ABERNETHY ROAD, 575 (L218) OAKFORD – PROPOSED EDUCATIONAL ESTABLISHMENT

Form 1 – Responsible Authority Report (Regulation 12)

Figure 8: Design of buildings

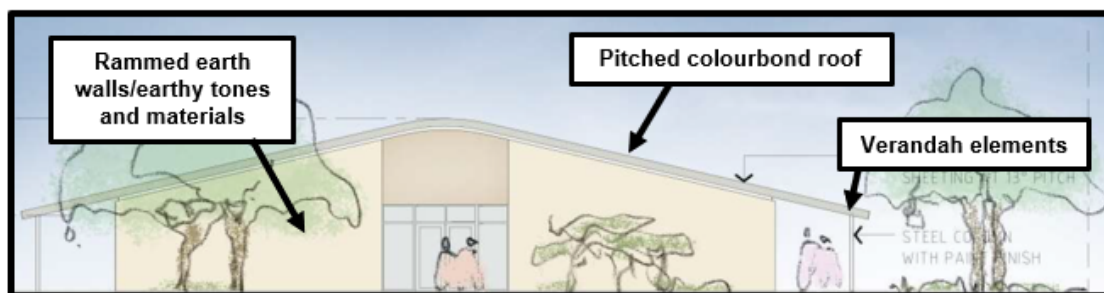
Officers consider this built form design compliments the rural characteristics of the locality, consistent with the previously mentioned objective of the zone:

residential estate to the east. Should the development be considered for approval, the approach to fencing would be recommended to change, insofar that a fencing style such as earth blocks or rammed earth structure be adopted, with the infill garrison sections being a less dominant aspect.

Figure 15: Proposed additional 15m long turning lane

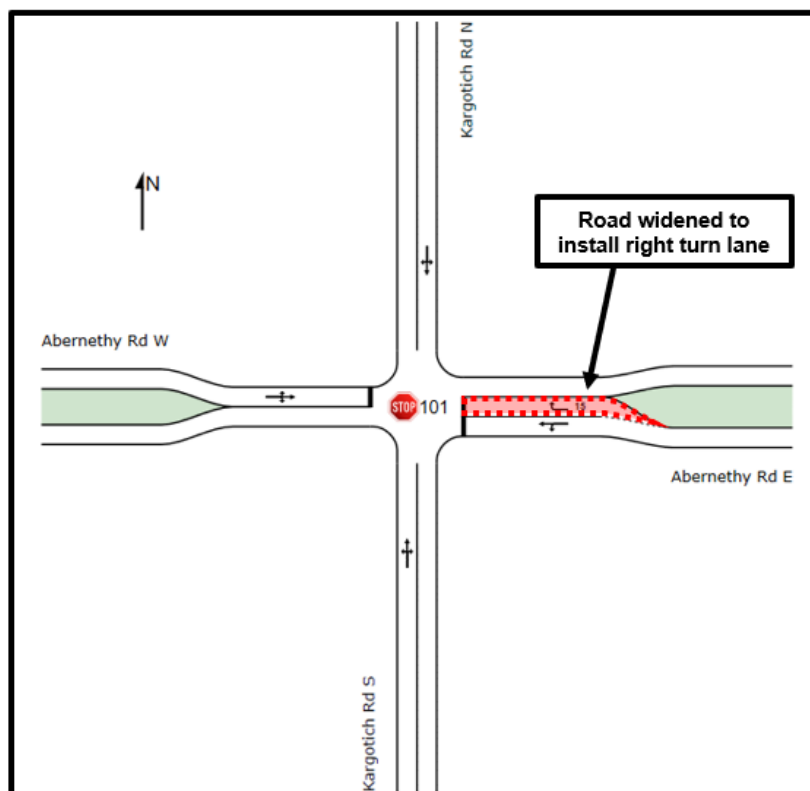
Despite the proposed additional lane, the change of service to 'level D' changes from 'over capacity' to 'just under capacity'. The turning lane is only 15m in length, therefore only two or three vehicles could utilise it. Given the still significant wait times for traffic turning right from Abernethy Road onto Kargotich Road northbound, traffic may still queue beyond the turning lane, reducing the intersection back to a single lane in any case. This design solution is based upon the first stage of the school only and does not address the full capacity of 1,200 students proposed.

Officers consider that if a turning lane is provided at the east side of the intersection, then it is reasonable to expect that a mirrored treatment should be installed on the west side of the intersection for vehicles leaving the site. The required widening, tree removal and service relocation required to facilitate this is not documented by the proposal, with no information that depicts whether this is practical or if the applicant agrees to fund this full cost impact. Officers also consider it to be inconsistent with orderly and proper planning to relocate infrastructure, only then to require the same infrastructure to be relocated again to accommodate the roundabout.

Figure 18: Provided auxiliary turn lane into first access point

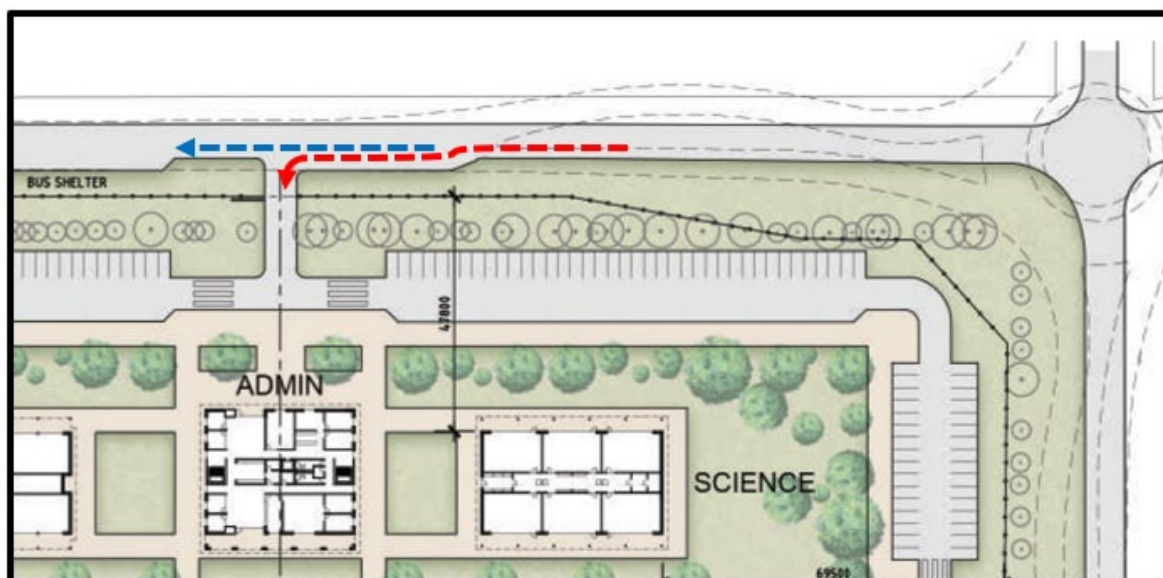
Officers consider the provision of an auxiliary turn lane of approximately 32m would support efficient access to the site. As shown below, the traffic turning into the high school (red) would not result in queue backs impacting buses or traffic moving to the primary school entry (blue). The SIDRA analysis indicates that all access points would operate at a good level, with no quee backs or service delays.

Figure 21: Noise modelled from the noisiest outdoor activities (basketball)

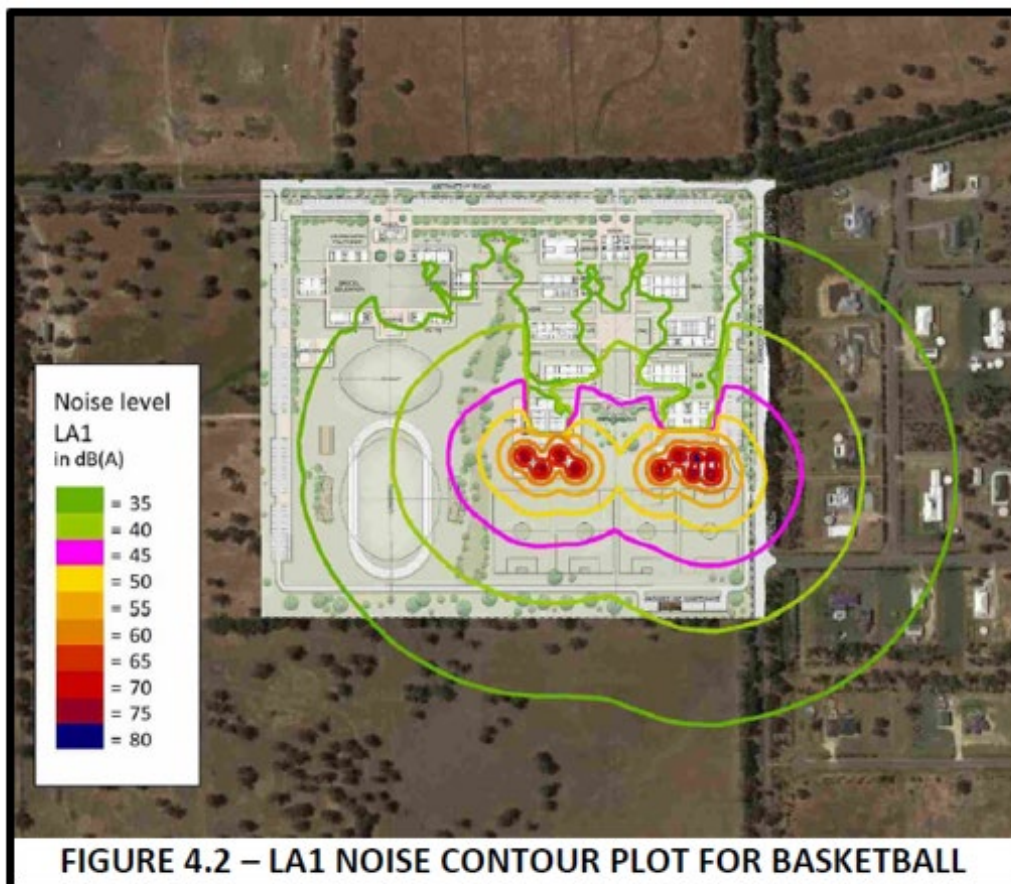
Officers consider that given basketball activities may occur for extended periods during recess, lunch, during sports classes or after school, the L_{A10} noise category may be more applicable. Despite this, the modelling would still suggest compliance with the *Noise Regulations* as the requirement would be to meet 45dB of L_{A10} noise. While the projection of 42dB complies, Officers consider it is close to the assigned levels. Therefore, additional design considerations such as the provision of a noise wall are considered applicable to assist in managing the amenity of nearby residents effectively.

Figure 25: Noise levels generated by existing traffic in the locality

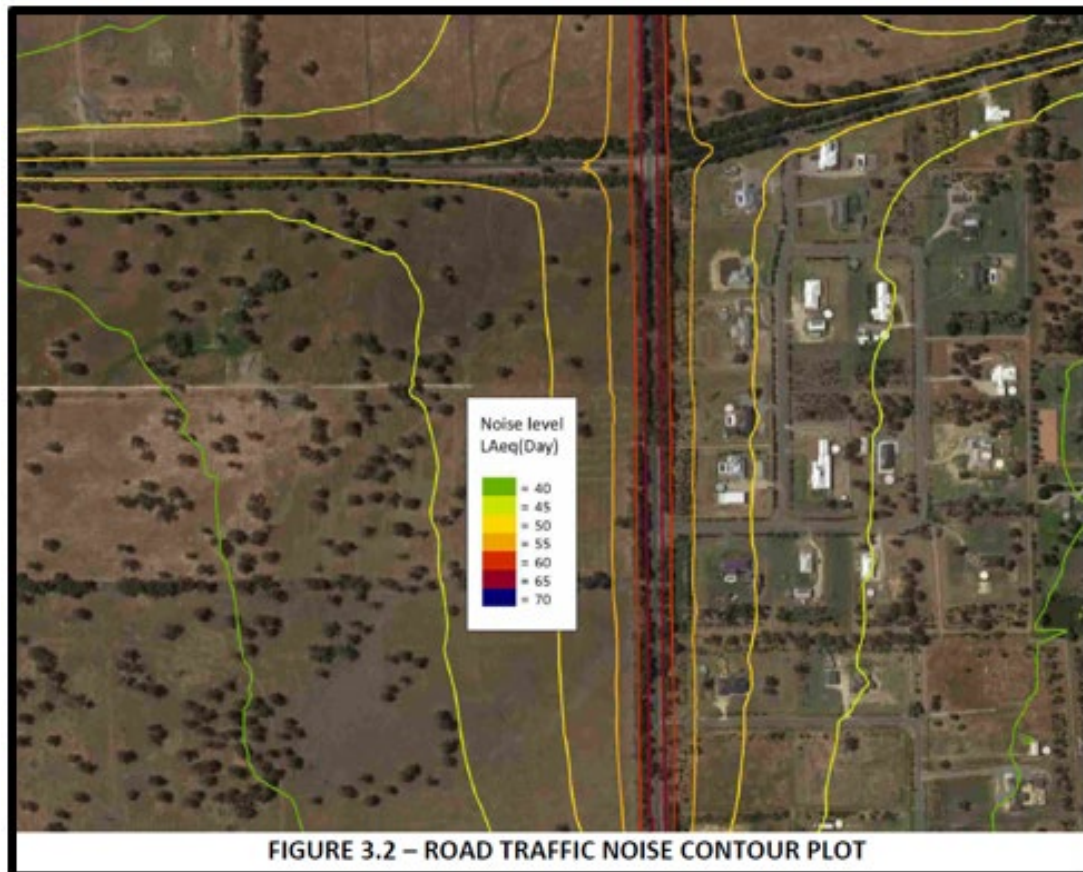
Officers consider that despite complying with the *Noise Regulations*, the modelled noise only just meets the assigned levels. Furthermore, comparing noise generated from the traffic on Kargotich Road and Abernethy Road (L_{Aeq}) and noise generated by the school (L_{A10} or L_{A1}), is not considered a relevant comparison. This is given noise under L_{Aeq} may only reach its maximum average over a four, eight or 16-hour period. Meaning there are far longer periods between when noise from this source would be noticeable, compared with the more frequent and intense noise generating activities of the school.

Officers consider as the development maintains general compliance with the *Noise Regulations* it would be in keeping with the expected amenity of the locality, by way of noise. However, it is considered reasonable that additional design measures be applied to further reduce and mitigate noise levels received by sensitive receptors in the locality. Therefore, should Council recommend support for the development a condition has been provided to require a detailed Noise Management Plan be prepared by an accredited acoustic consultant.

Figure 28: Location of proposed 'living stream' or drainage swale

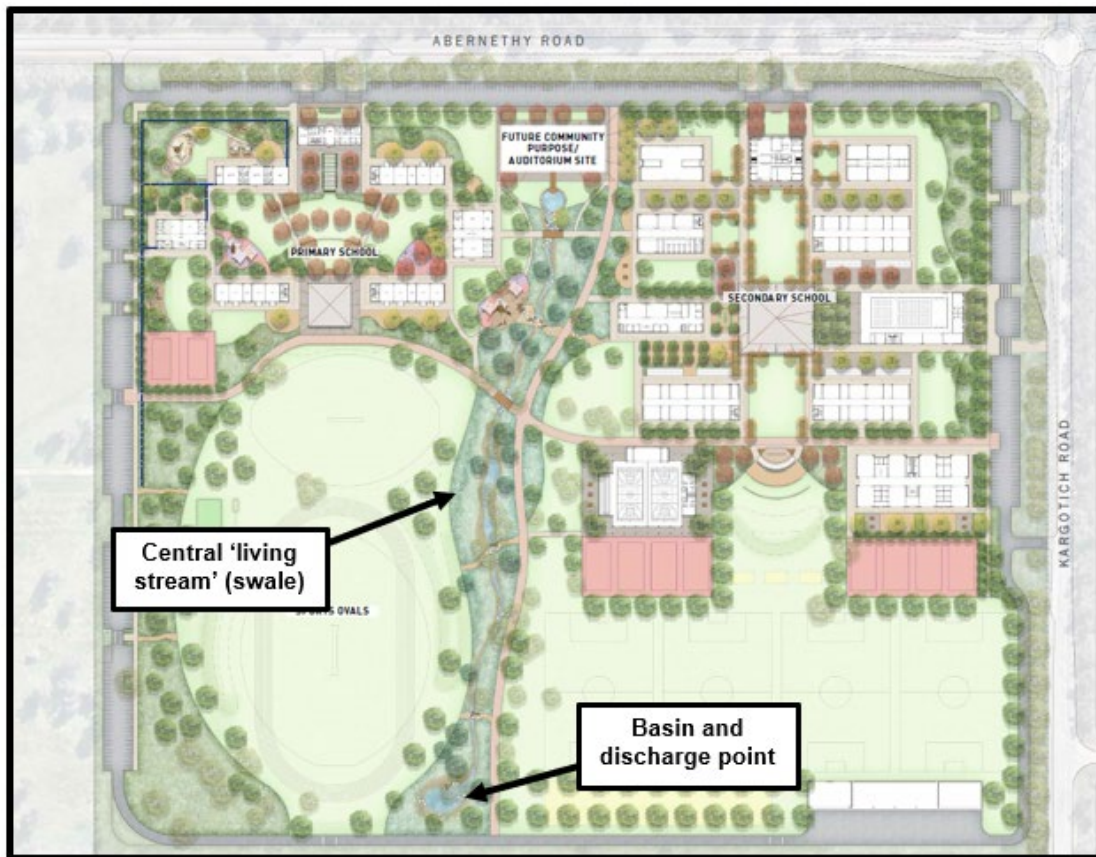
Officers consider that in principle there is merit to the methodology of stormwater management proposed. The 'living stream' concept provides a model consistent with the 'wetland' nature of the site. Furthermore, it would provide opportunity the planting of native vegetation which can strip nutrients and contaminants, managing the quality of water entering the ground. The proposal in its current form would need additional details regarding the following:
